MIL-PRF-19500/685
AMENDMENT 1
16 August 2001

PERFORMANCE SPECIFICATION

SEMICONDUCTOR DEVICE, FIELD EFFECT, RADIATION HARDENED
TRANSISTOR, N-CHANNEL SILICON TYPES 2N7475T1, 2N7476T1 AND 2N7477T1
(TOTAL DOSE AND SINGLE EVENT EFFECTS)
JANTXVR AND JANSR

This amendment forms a part of MIL-PRF-19500/685, dated 6 October 2000, and is approved for use by all Departments and Agencies of the Department of Defense.

FIGURE 3. Safe operating area graph."

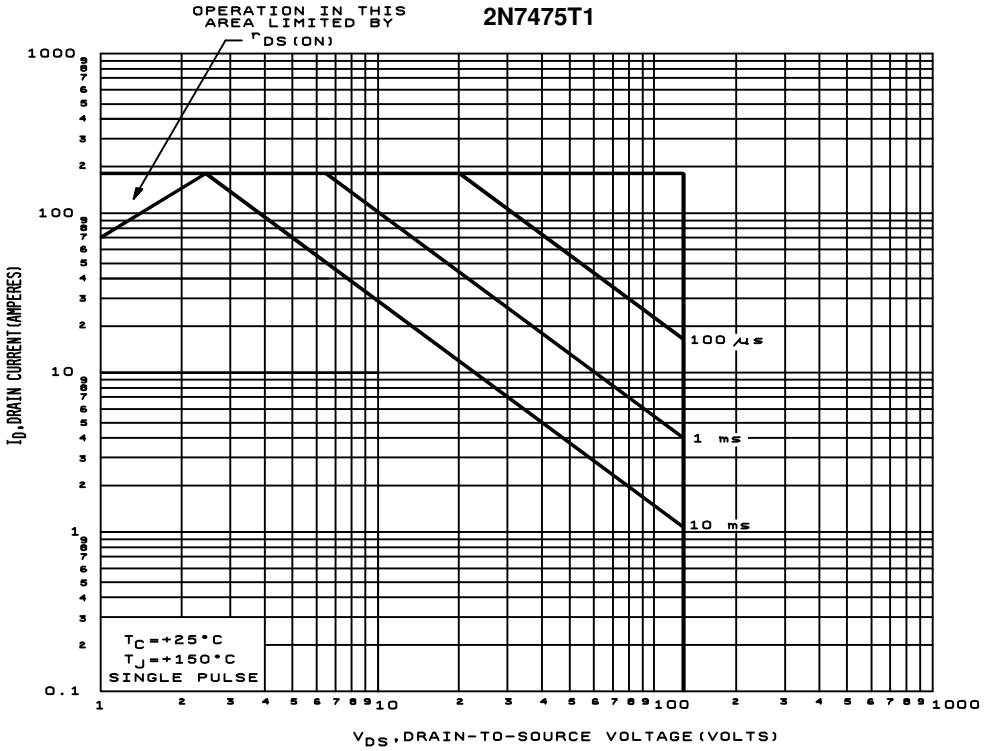
FIGURE 3, delete and substitute:

FIGURE 4. Safe operating area graph."

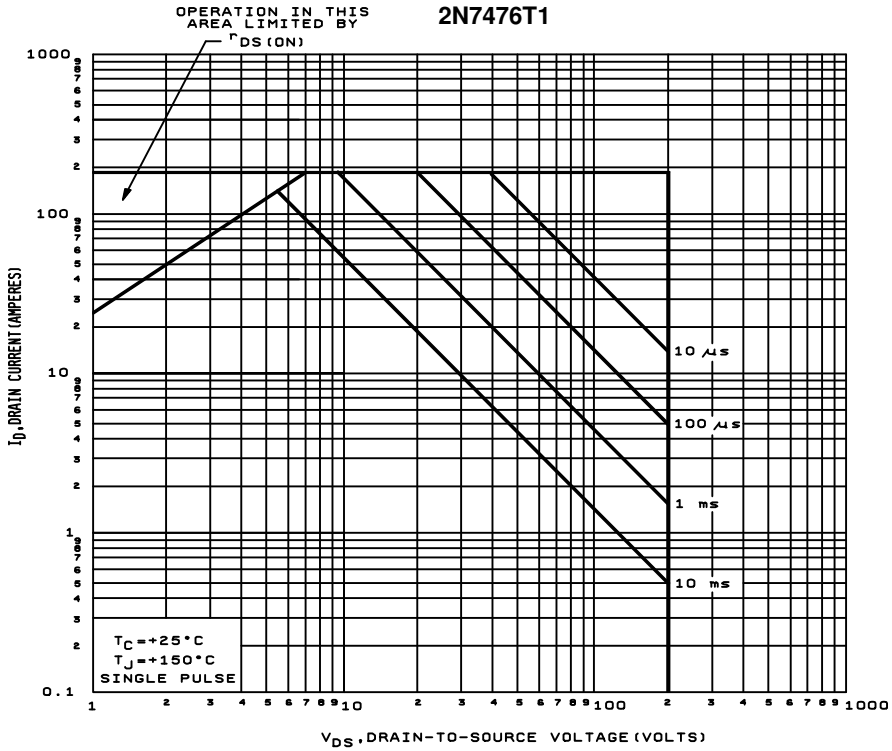
FIGURE 4, delete and substitute:

FIGURE 5. Safe operating area graph."

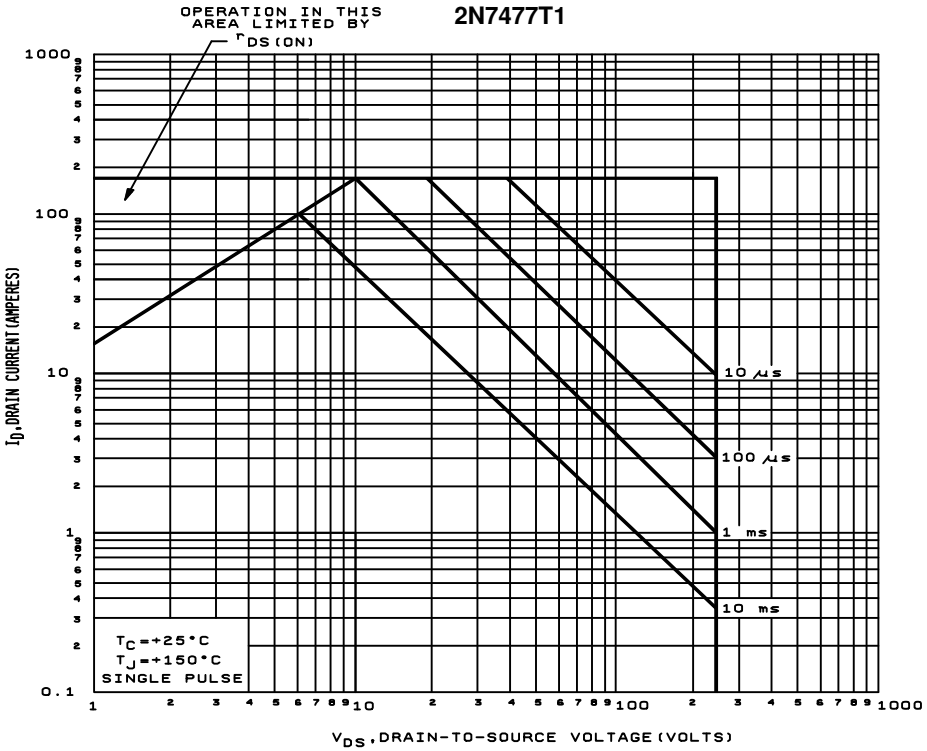
FIGURE 5, delete and substitute:
